SUBJECT: ISSUANCE OF AMENDMENT NO. 83 TO FACILITY OPERATING LICENSE NO. NPF-2 AND AMENDMENT NO. 76 TO FACILITY OPERATING LICENSE NO. NPF-8 REGARDING ROD CLUSTER CONTROL ASSEMBLY FULLY WITHDRAWN DEFINITION - JOSEPH M. FARLEY NUCLEAR PLANT, UNITS 1 AND 2, (TAC NOS. 76988 AND 76989)

Amendment No. 83
License No. NPF-2

Amendment No. 76
License No. NPF-8

SAFETY EVALUATION BY THE OFFICE OF NUCLEAR REACTOR REGULATION
SUPPORTING AMENDMENT NO. 83 TO FACILITY OPERATING LICENSE NO. NPF-2
AND AMENDMENT NO. 76 TO FACILITY OPERATING LICENSE NO. NPF-8

Figure 3.1-1 Rod Group Insertion Limits Versus Thermal Power Three Loop Operation

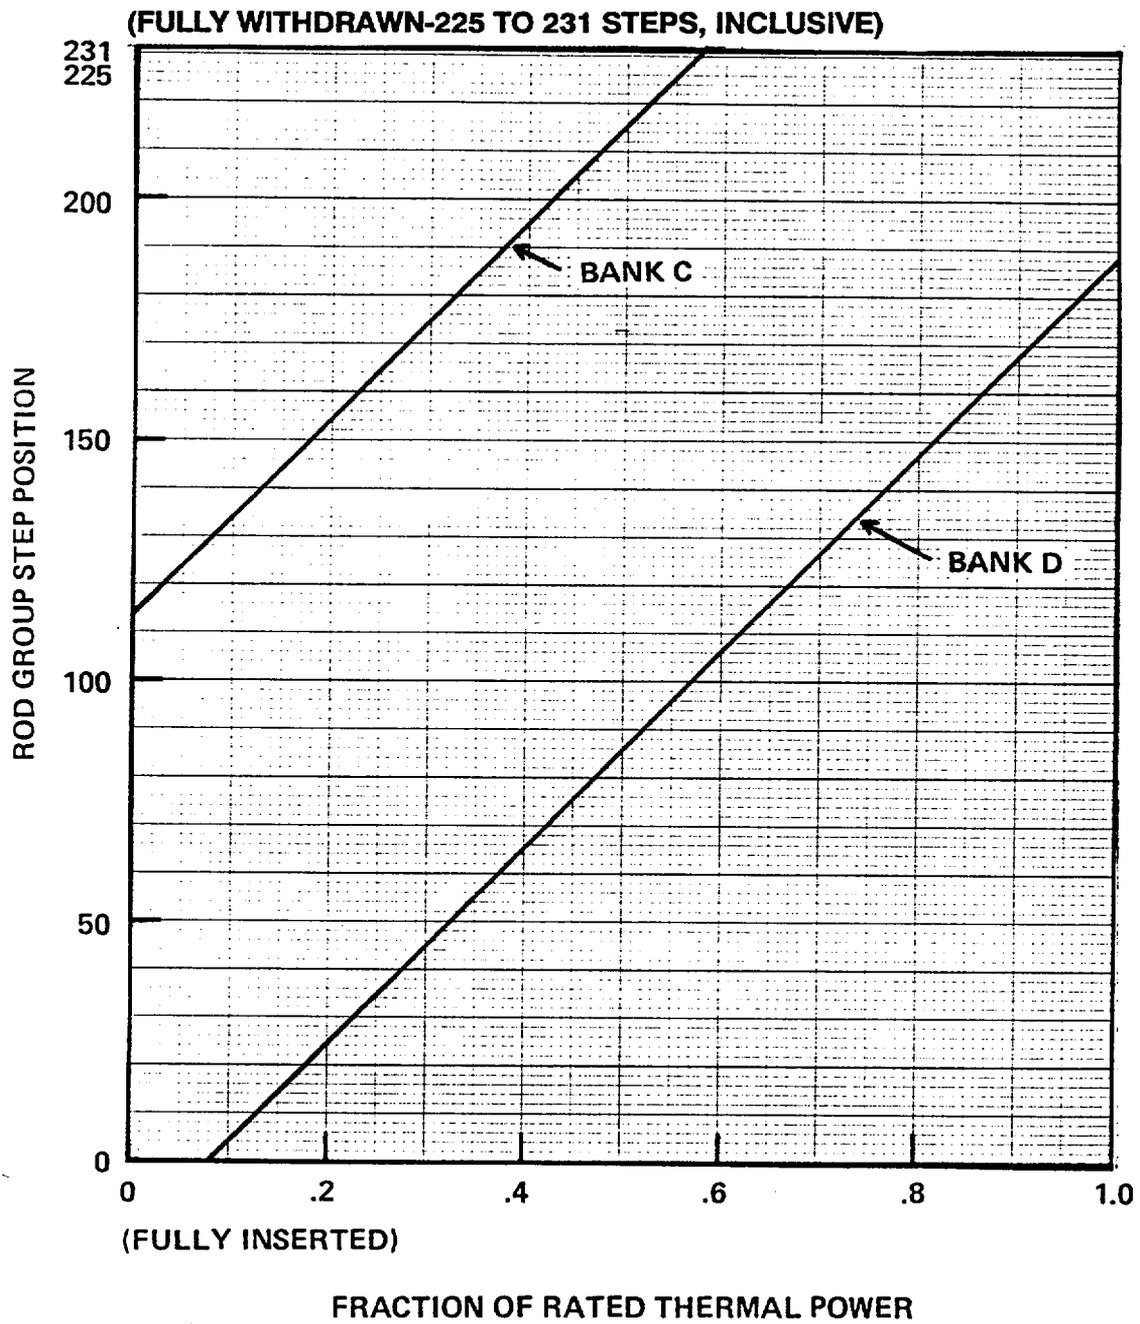
The amendments change the Technical Specifications to redefine the fully withdrawn position of all rod cluster control assembly (RCCA) banks to minimize localized RCCA wear. Currently, the fully withdrawn position for the control and shutdown RCCA banks is defined as 228 steps above rod bottom. These amendments allow the control and shutdown RCCA banks to be designated as fully withdrawn between steps 225 and 231, inclusive. These changes are consistent with Westinghouse's recommendation to axially reposition the RCCAs up to three steps to distribute wear to other locations on the RCCA rodlets in order to extend rod life.

The licensee proposed defining "fully withdrawn" to mean between 225 and 231 steps, inclusive, above reactor bottom for all RCCA banks. Between 228 and 231 steps, the RCCAs are withdrawn at least two steps above the active fuel. Thus with respect to core physics, the effects are equivalent. Also at 231 steps the RCCAs will remain inserted in the guide thimbles of the fuel assemblies and thus will allow for a smooth rod drop. The rod drop time assumed in the safety analysis will still be bounding. When the RCCAs are withdrawn to 225 steps, they will actually be inserted one step (0.63 inches) into the active fuel. Thus the key physics safety parameters were evaluated to determine if the change invalidated any safety analysis assumptions. The effect on the calculation performed to verify shutdown margin is minimal, a decrease of 0.03% delta-rho (change in reactivity). This effect can be accommodated by the available excess margin at end-of-life which is approximately 1.40% delta-rho. Other physics parameters such as core axial power distributions, differential and integral rod worth are affected only slightly. Sufficient margin exists in the safety analysis to account for these changes. The heat flux hot channel factor (F_0) is expected to increase by less than 1% in the bottom of the core and the axial offset will be more negative by less than 1%. There is sufficient margin to bound these effects.
